ADDENDUM NO. 3

CITY OF MASSILLON, OHIO
WWTP UPGRADE 2000

SK-P17-003

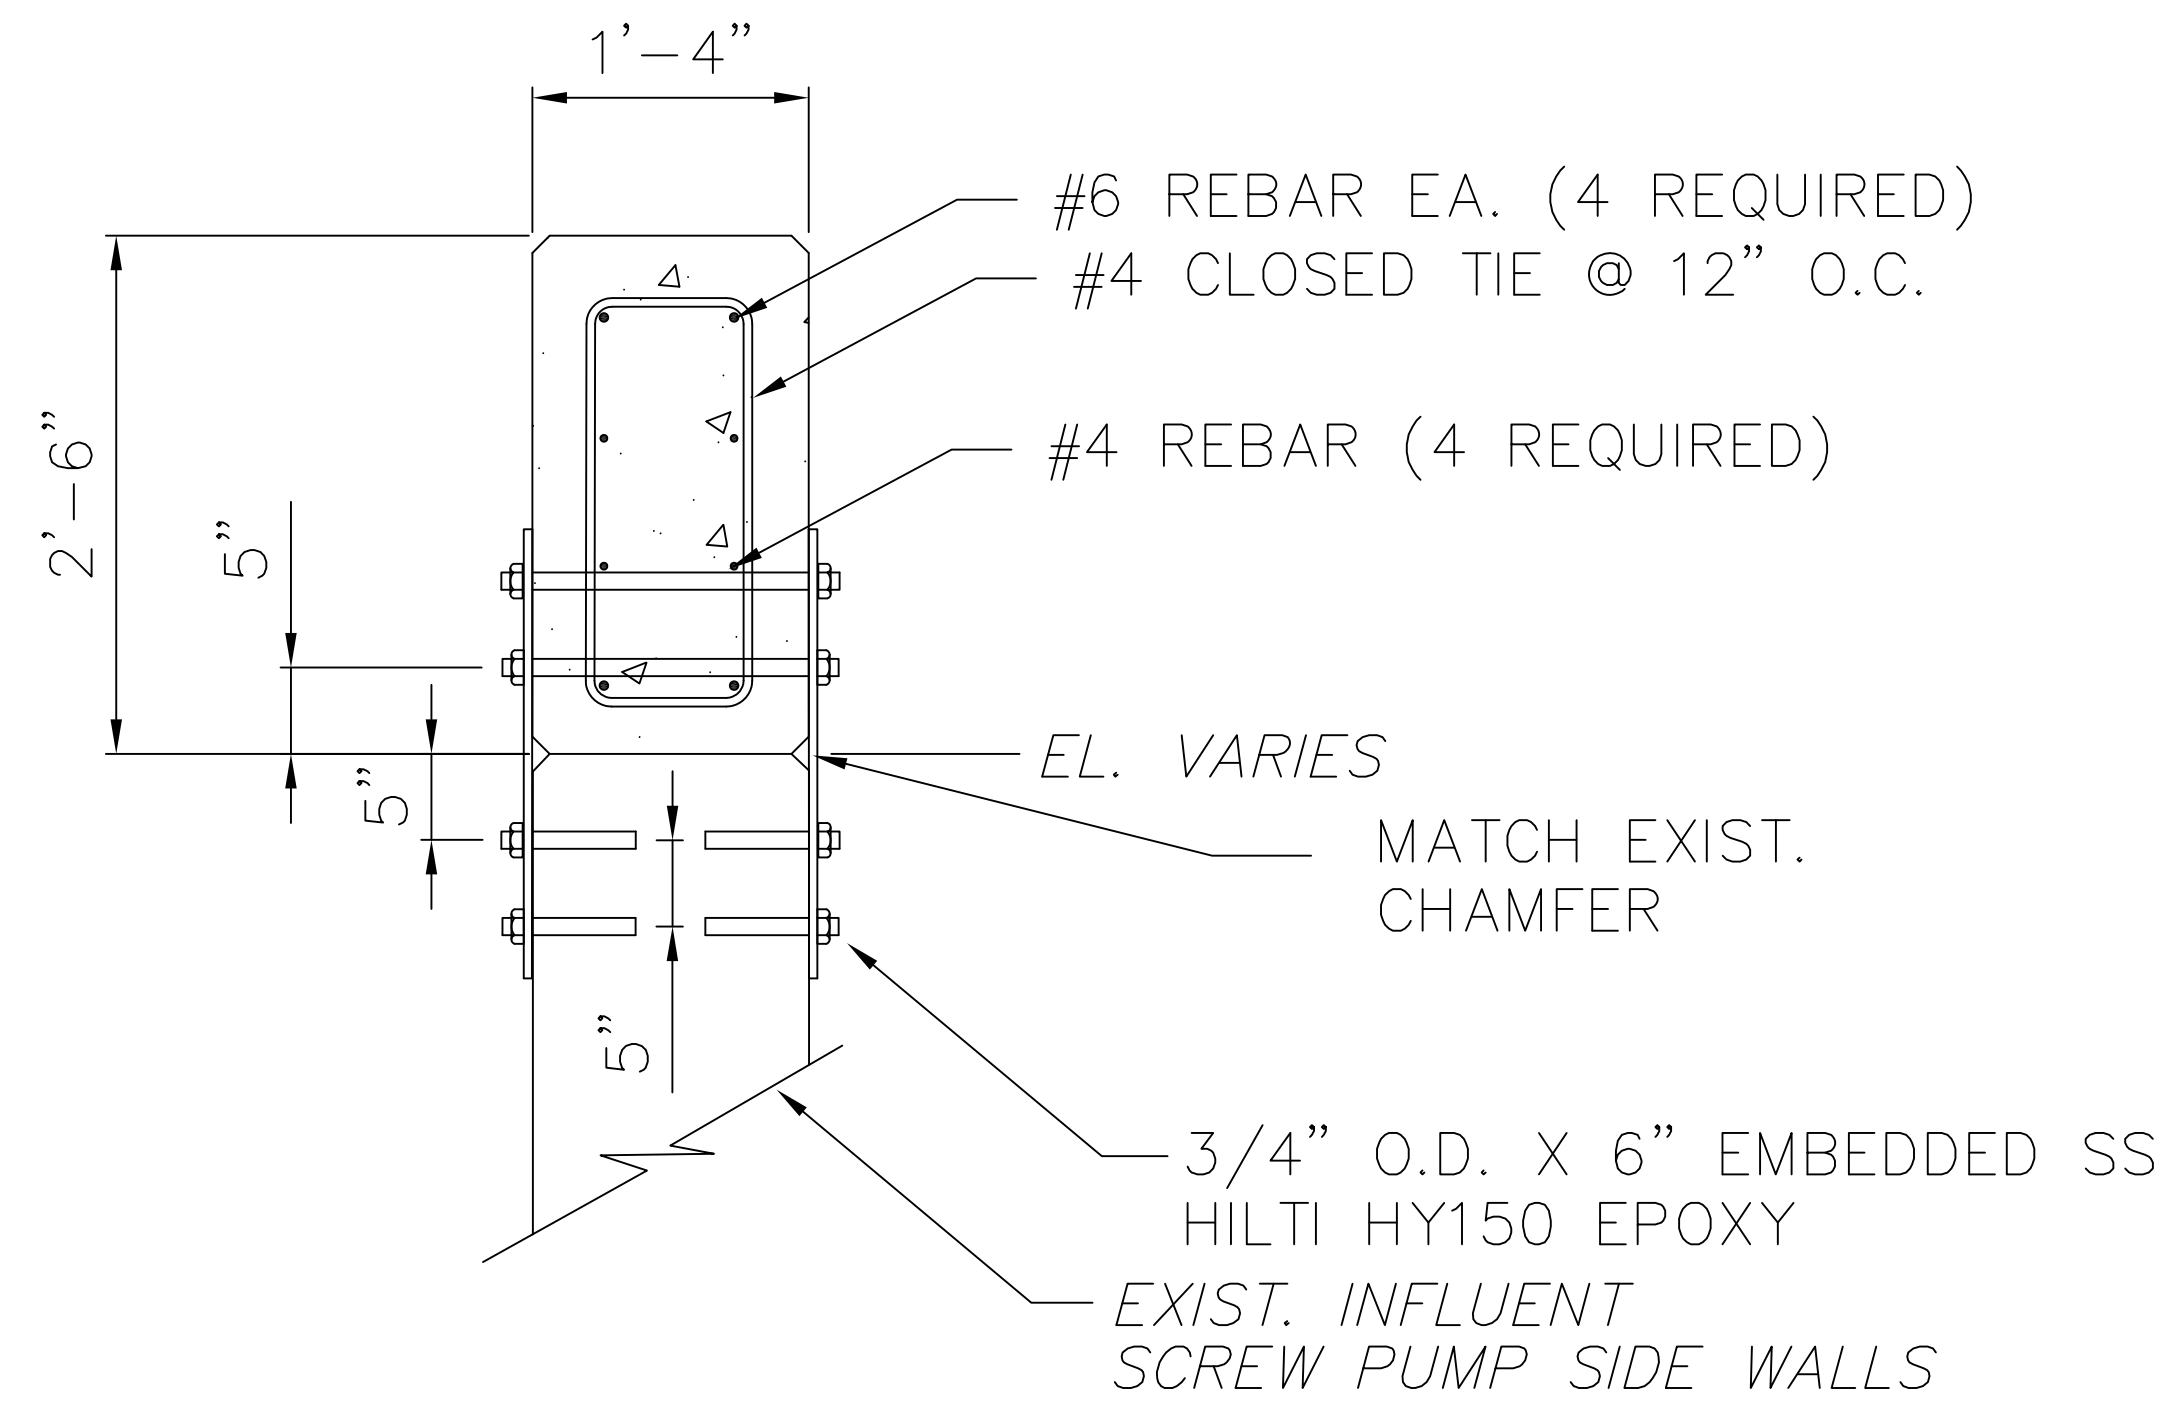
WALL SECTION
SCALE: 1/2" = 1'-0"
